# **Technical Advisor Report on the Transpower New Zealand Ltd IPP Proposal for RCP2**

**Report to  
The Commerce Commission**

**Strata Energy Consulting Limited  
and  
Energy Market Consulting Associates**

**16 May 2014**

**Figure 3 Reforecast movement in base capex (\$m)**

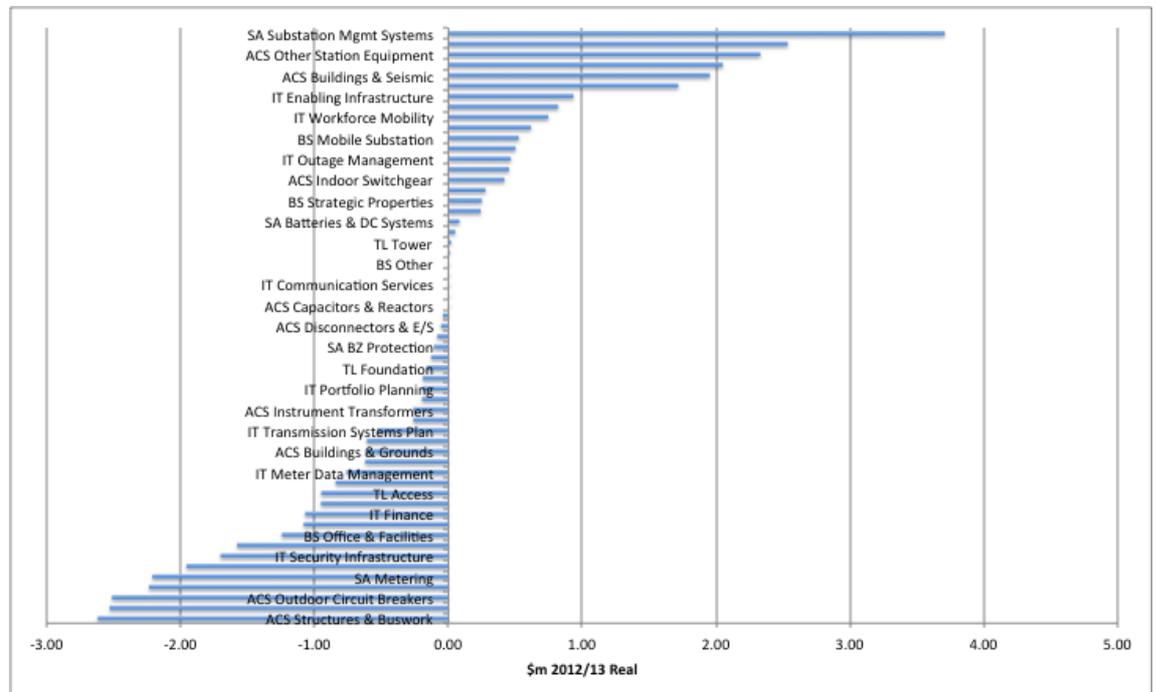
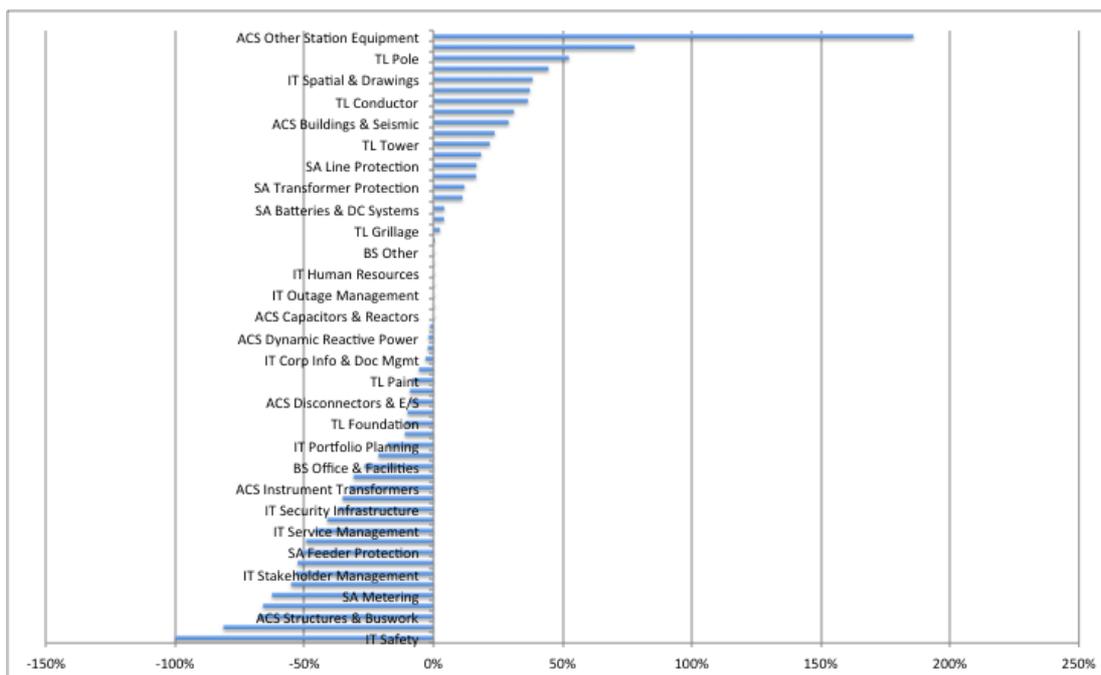
- 110 In considering the reasons provided by Transpower, it appears that the RCP1 allowance, which was based on Transpower's forecast, was around 10% greater than what will be expected to be spent during RCP1.
- 111 Figure 3 shows the variance between the forecast 2013/14 base capex components in the December 2013 MP01 proposal and the reforecast provided in February 2014 in response to Commission question Q021. Several significant changes are evident in the components of the forecast. The overall difference is -3% (-\$6.7m).

112 We have observed that a relatively small variation of 3% overall change in the forecast for 2013/14 is based on a number of more significant movements in individual base capex components. Given that only a few months separated the submission of MP01 and the 2013/14 reforecast, such sizable movements are perhaps surprising.

**Figure 33: Power transformer AHI variations**

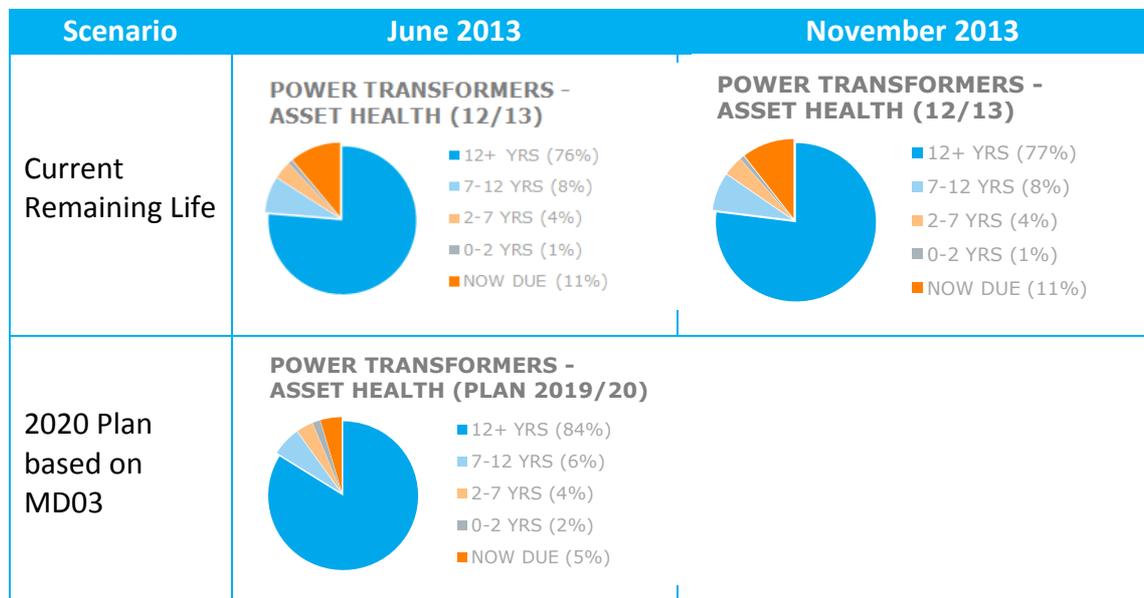
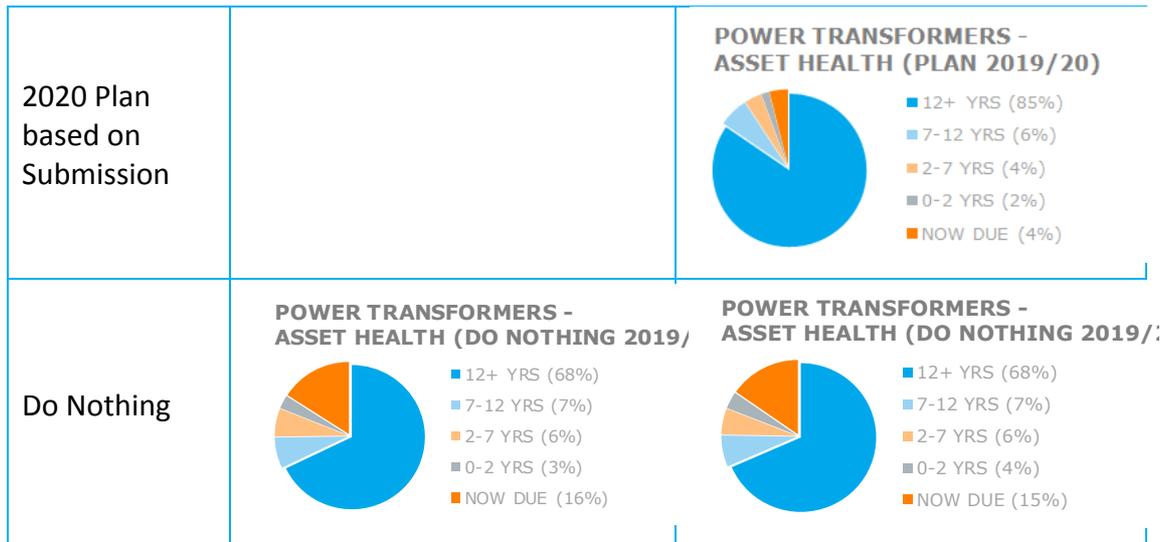
244 Figure 33 provides an example for the changes in power transformer asset fleet that occurred between June and November 2013.

**Figure 35 APR demand forecasts in recent years**

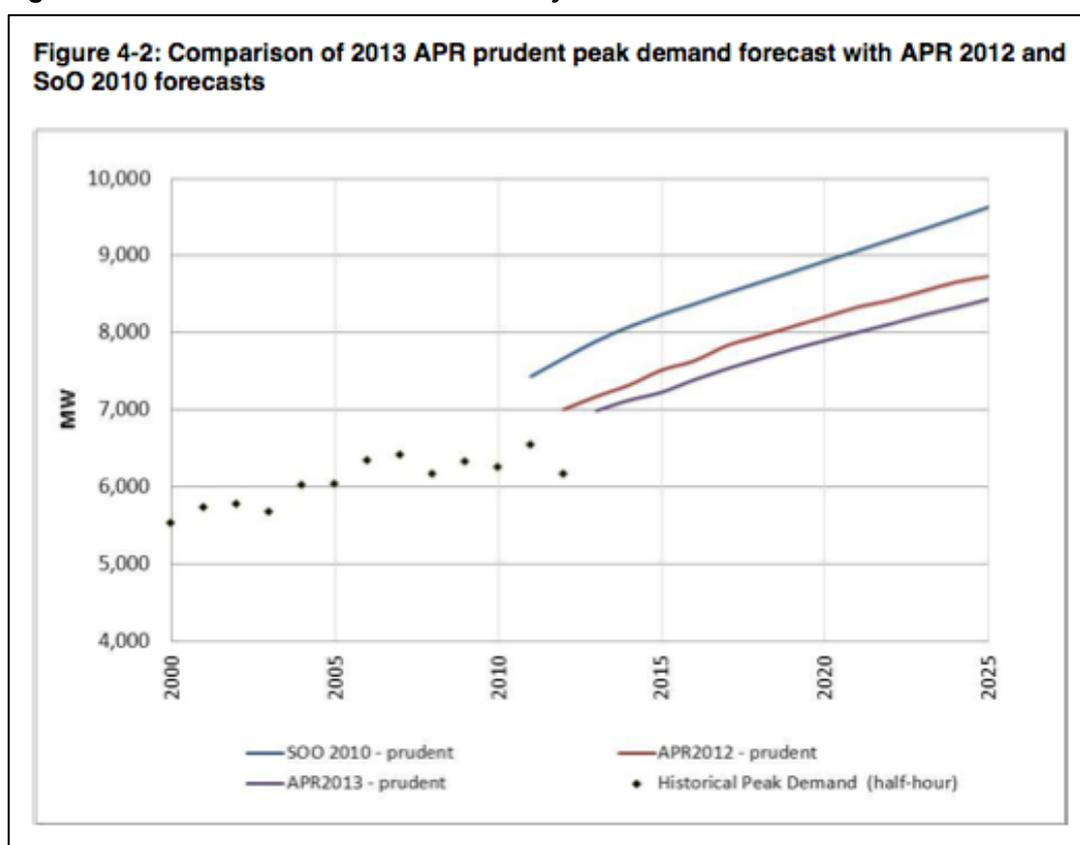
297 The pattern of recent demand forecasts is shown in Figure 35, which is reproduced from the 2013 APR.

- (a) the adequacy of its shorter-term (i.e. 1 – 5 years) forecasts, illustrated in Figure 35 where successive prudent demand forecast curves are pushed materially outwards in time; and

**Figure 36 Most recent (2014 APR draft) peak demand forecast**

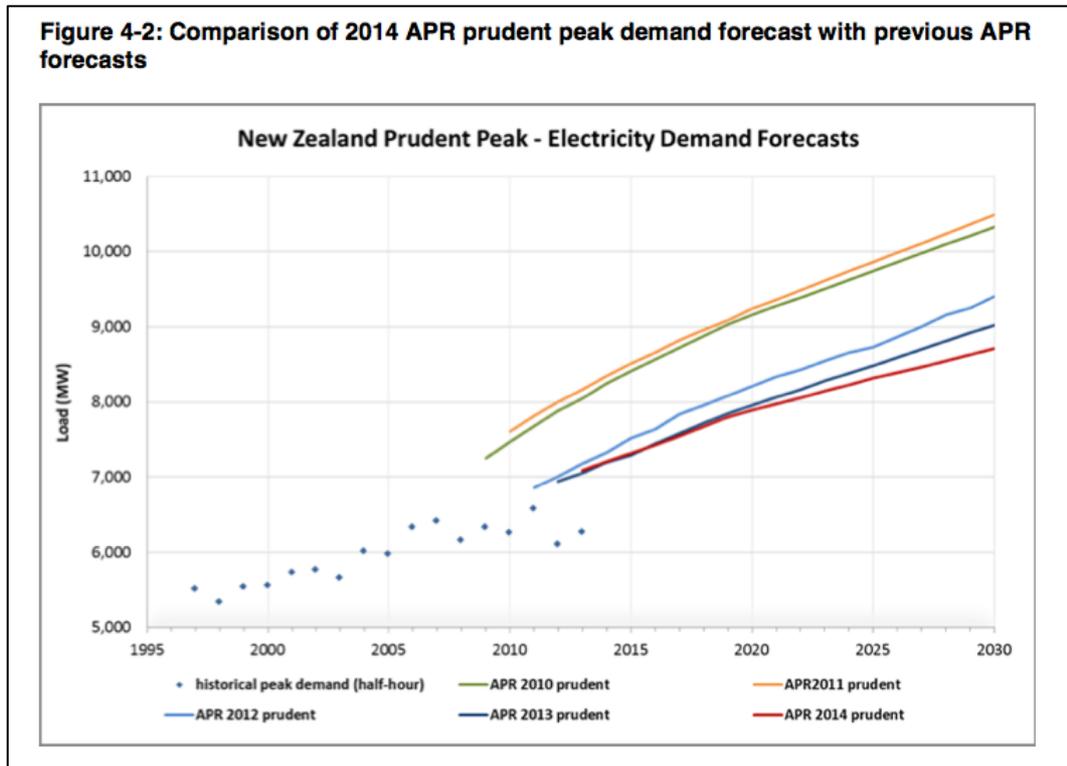
302 From visual inspection of Figure 36, the largest year-on-year peak demand increase (which appears to be 2003 to 2004, within a relatively high-growth period) is around 50% of the gap between the 2013 actual and P90 peak demands. This leads to an overall impression of on-going conservatism underpinning Transpower’s P90 prudent forecast, which is probably an artefact of the ensemble approach to peak demand forecasting that Transpower favours. The national forecast is related to the regional forecasts that drive the timing of much of the E&D base capex forecast.

**Figure 37 RCP2 E&D forecast proposed and adjusted (\$m)**

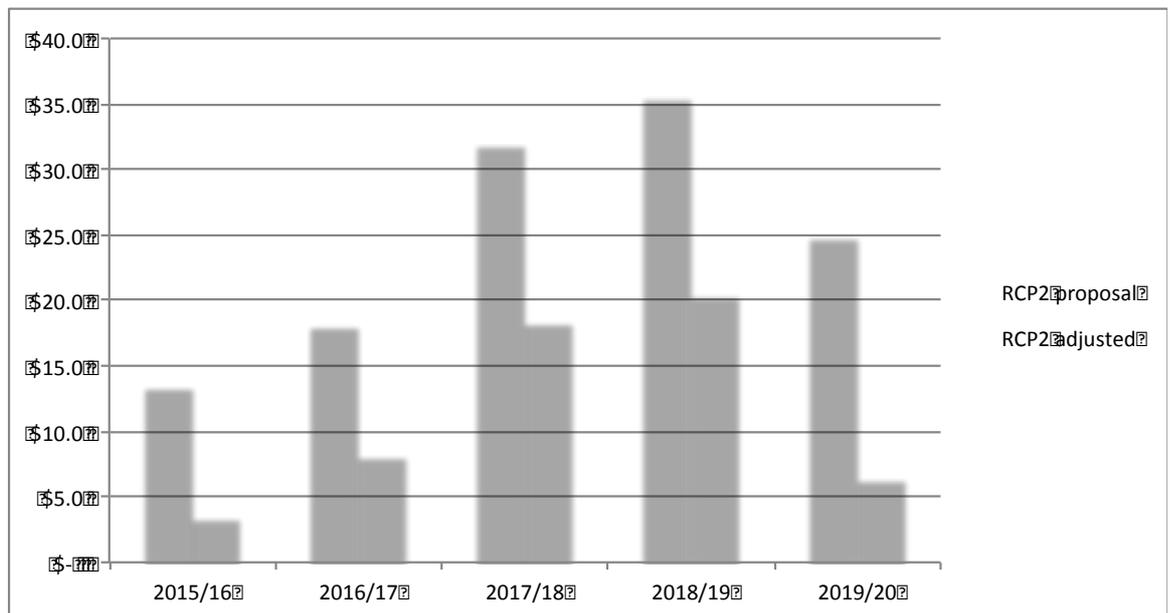
319 It is evident from Figure 37 that the first two years of RCP2 show a significant drop in expenditure when compared with the immediately preceding years in RCP1 and the final three years of RCP2. This appears to reflect a 'pipeline' issue caused by very few E&D base capex projects being undertaken in the latter years of RCP1 and the larger project expenditures forecast to occur in the latter years of RCP2.

**Figure 46 Power transformer average remaining lives**

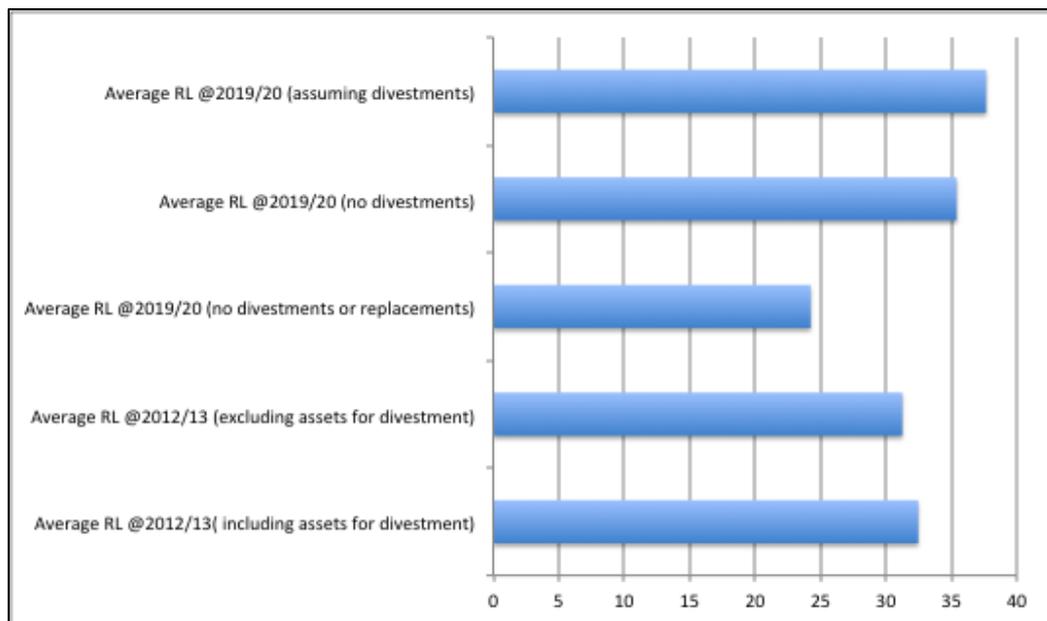
380 Figure 46 shows that the proposed asset divestment programme has a relatively low impact on remaining life in 2019/20 under Transpower's proposed transformer replacement capex. The average remaining life will improve from 31 years to 38 years if the replacement and divestment programmes are completed as planned. However, if the divestment programme is not implemented, the average remaining life in 2019/20 will be 35 years.

**Figure 48 Effect of delayed expenditure – Outdoor to indoor 33 kV switchgear conversions**

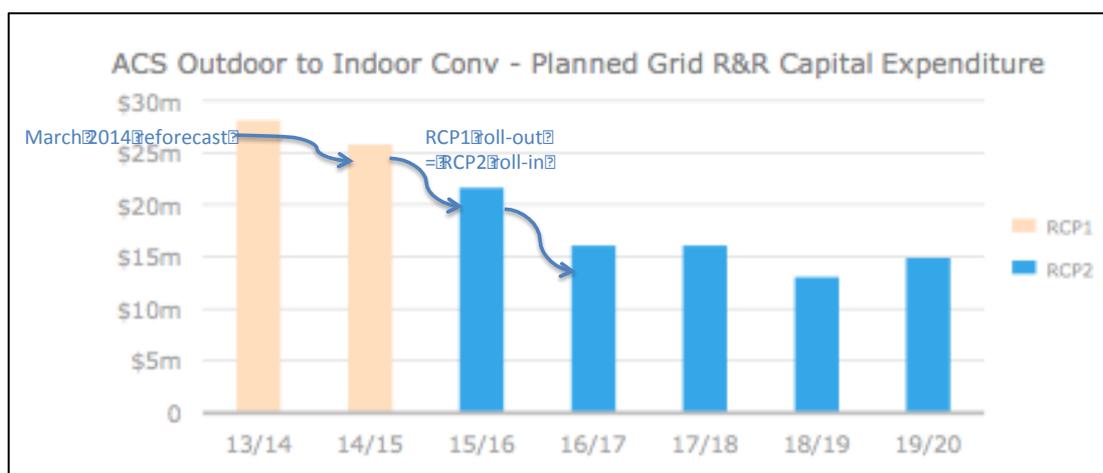
395 This decrease likely represents an under-delivery against plan (as opposed to a productivity gain by commissioning more conversions at lower than planned cost), which will have the effect of delaying planned expenditure into succeeding years, as shown in Figure 48.

**Figure 52 SMS rollout proposed capex**

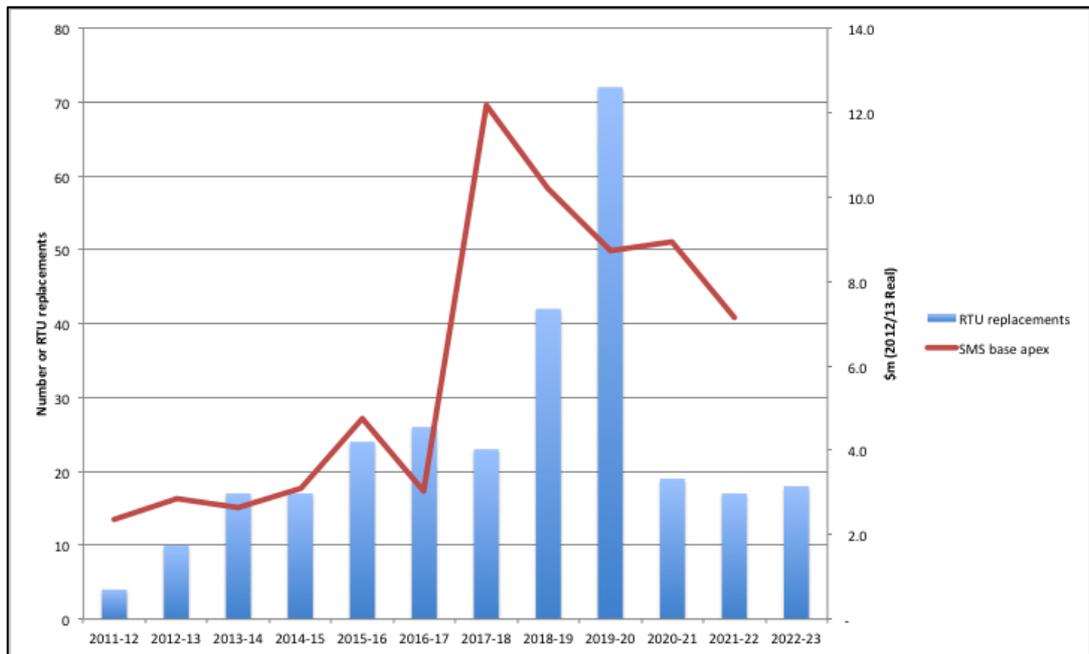
420 The above charts highlight the rapid conversion during RCP2. The speed of the proposed conversion programme can also be seen in the proposed SMS capex profile for RCP2.

**Figure 53 Revised SMS rollout capex**

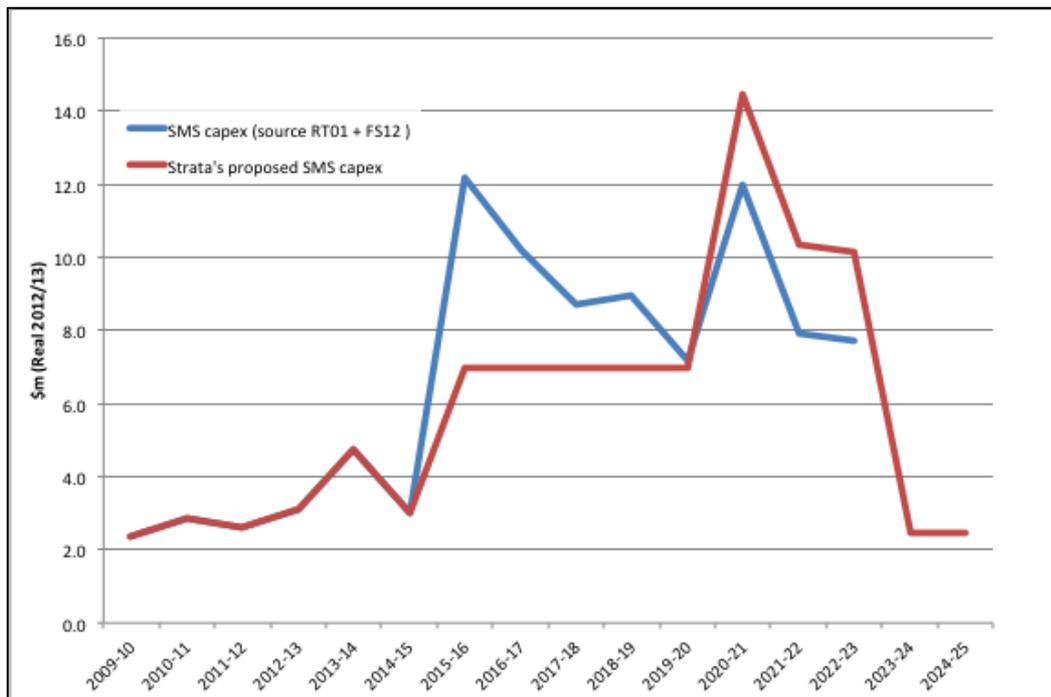
430 As shown in Figure 53 (the blue line), the SMS rollout is rapid. Given that a third of the RTUs are current models less than six years old and that spares for older models may be released as units are replaced, we consider that a SMS slowed rollout option should be considered.

432 Figure 53 and Table 10 show our recommended SMS capex profile.
